Product Change Notification

1. ECR #: 221404
Notification #: 673

3. Series:
• 240 - 240 ST JACK FOR COMPRESSION MOUNT

4. Part #'s Affected
• 240-J-P-EP-ST-CMM-X-X

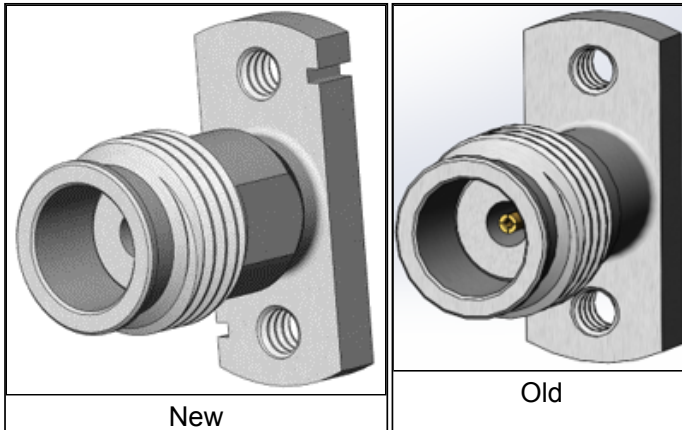
5. Description of Change:
We added two grooves on our body for PCB mounting alignment and a flange for our custom wrench to prevent rotation.

6. Method of Identifying Change
Two grooves and a flange on the new body

7. Reason for Change:
For better alignment onto the PCB

8. Impact of Change on Form, Fit, or Function:
• Form - Form change
